ADDENDUM NO. 07

February 18, 2010

Project: **Dickinson High School Additions and Renovations**
Dickinson Independent School District

JOB NO. 1273
SHEET NO. ADD-07-1
DATE: 2/22/2010
DRAWN BY: D.P.G.
CHECKED BY: C.C.

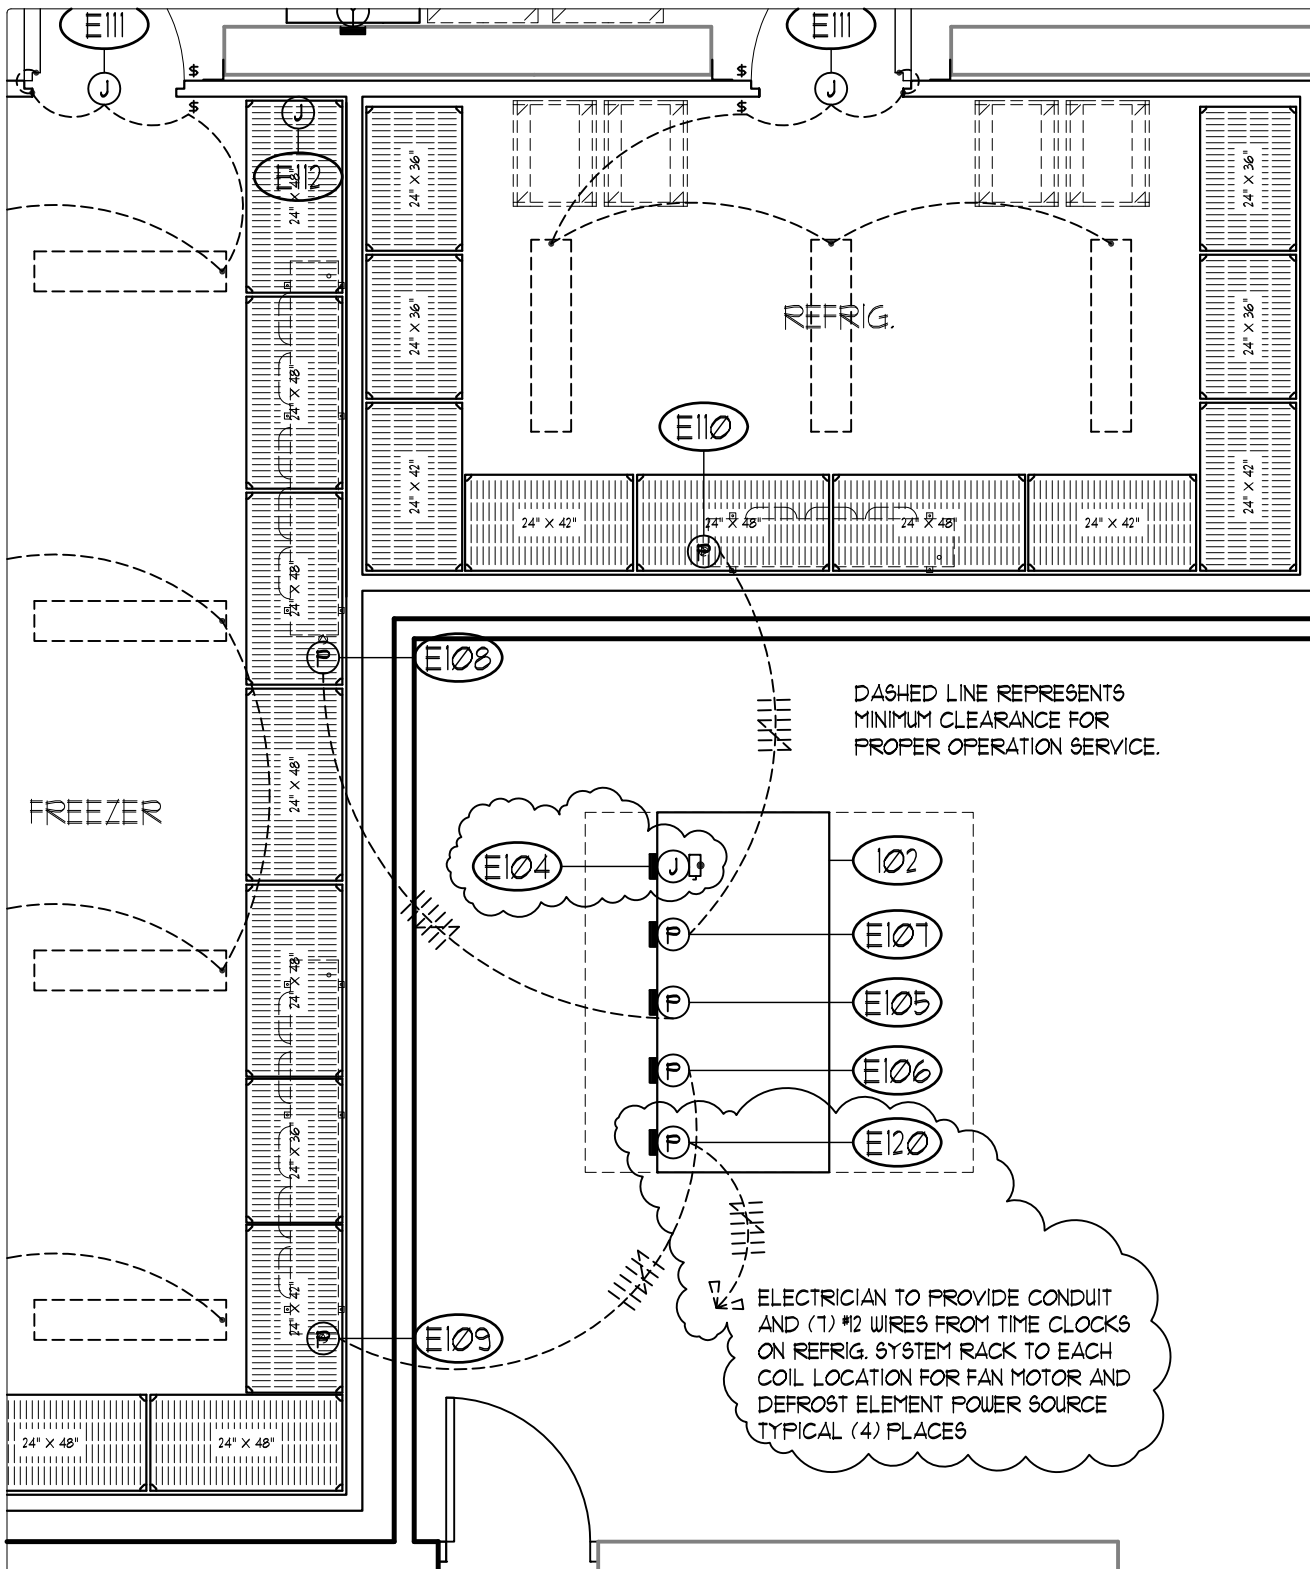
11. Sheet FS-2 Foodservice Equipment Floor Plan-Coffee Bar: REVISE Equipment Floor Plan to ADD Walk-In Cooler, refer to attached drawing sheet **ADD-07-1**.

12. Sheet FS-7 Foodservice Equipment Plumbing/Mechanical Plan-Coffee Bar: ADD Plumbing Rough-In for Walk-In Cooler, refer to attached drawing sheet **ADD-07-1**.

14. Sheet FS-9 Foodservice Equipment Electrical Plan-Kitchen: REVISE Electrical Schedule, refer to attached drawings sheet **ADD-07-3**.
15. Sheet FS-10 Foodservice Equipment Electrical Plan-Coffee Bar: ADD Electrical Rough-Ins, refer to attached drawings sheet **ADD-07-1**.

PLUMBER TO PROVIDE
2" SLEEVE THRU WALL
AT 12" AFF FOR COIL
DRAIN LINES.

COIL DRAIN LINES TO BE
PROVIDED BY AND INSTALLED
BY SECTION 11400

JOB NO. 1273
SHEET NO. ADD-07-2
DATE: 2/22/2010
DRAWN BY: D.P.G.
CHECKED BY: C.C.

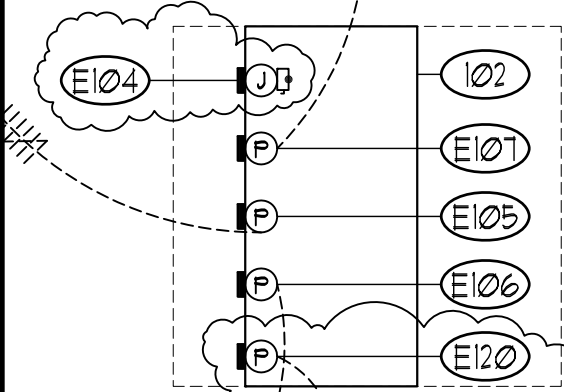
13. Sheet FS-9 Foodservice Equipment Electrical Plan-Kitchen: ADD/REVISE Electrical Rough-Ins for Refrigeration System, refer to attached drawing sheet **ADD-07-2**.

ELECTRICIAN TO PROVIDE CONDUIT
AND (7) #12 WIRES FROM TIME CLOCKS
ON REFRIG. SYSTEM RACK TO EACH
COIL LOCATION FOR FAN MOTOR AND
DEFROST ELEMENT POWER SOURCE
TYPICAL (4) PLACES

NOTE:
GENERAL CONTRACTOR TO PROVIDE EQUIPMENT
PAD FOR REFRIGERATION SYSTEM RACK-VERIFY
ROOF LOCATION AND TYPE OF PAD

JOB NO. 1273
SHEET NO. ADD-01-3
DATE: 2/22/2010
DRAWN BY: D.P.G.
CHECKED BY: C.C.

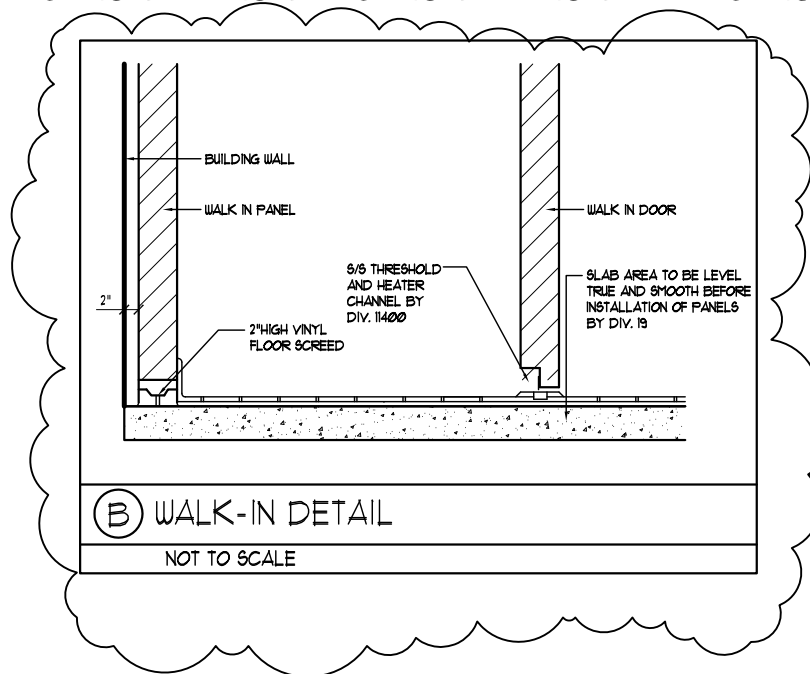
A. One (1) Thermo-Kool or Thermalrite single compartment assembly. Assembly to be 8'-8" A.F.F. from top of exterior walk in panels to finished floor. Provide per attached drawing sheet ADD-07-3, Detail B.

09. Sheet FS-1 Foodservice Equipment Floor Plan-Kitchen: REVISE Equipment Schedule, refer to attached sheet **ADD-07-3**.
10. Sheet FS-2 Foodservice Equipment Floor Plan-Coffee Bar: ADD Walk-In Detail & REVISE Equipment Schedule, refer to attached drawings sheet **ADD-07-3**.

16. Sheet FS-10 Foodservice Equipment Electrical Plan-Coffee Bar: REVISE Electrical Schedule, refer to attached drawings sheet **ADD-07-3**.
